文件编号 Document No.	ESP-07-2-007-03	文件名称 Document Name	产品/工艺变更通知 Product/Process Change Notice (PCN)
文件版本 Document Version	1.4	保存期限 Retention Period	5 年 5 years

ESP32 PICO 系列产品更新
Upgrade of ESP32 PICO Series Product

PCN 编号 PCN No.	PCN20221001	提出日期 Issue Date of PCN	2022/11/28
变更日期 Proposed Date of Change	2023/01/28	预计变更后产品首次出货日期 Proposed Date of First Shipment After Change	2023/02/28
PCN 类型/ PCN Category	☒ 客户需要批准/ Customer Approval Required ☐ 客户通知/ Customer Notification

2. PCB of ESP32-PICO-V3-ZERO Change Comparison

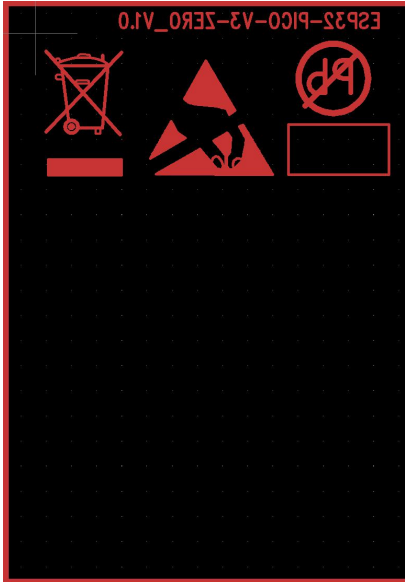
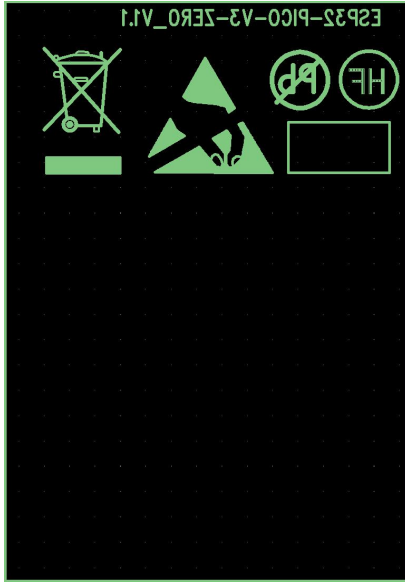
2) ESP32-PICO-ZERO 的模组背面丝印增加无卤 HF 标识, 模组 PCB 版本号升级。

'HF' marking is added on the bottom side of ESP32-PICO-ZERO and PCB version of ESP32-PICO-ZERO is upgraded in comparison with halogen modules.

模组名称 Module Name	变更前 Before Change	变更后 After Change
PCB of ESP32-PICO-V3-ZERO	Not halogen free	Halogen free
PCB Bottom Marking of ESP32-PICO-V3-ZERO		
PCB Version of ESP32-PICO-V3-ZERO	V1.0	V1.1
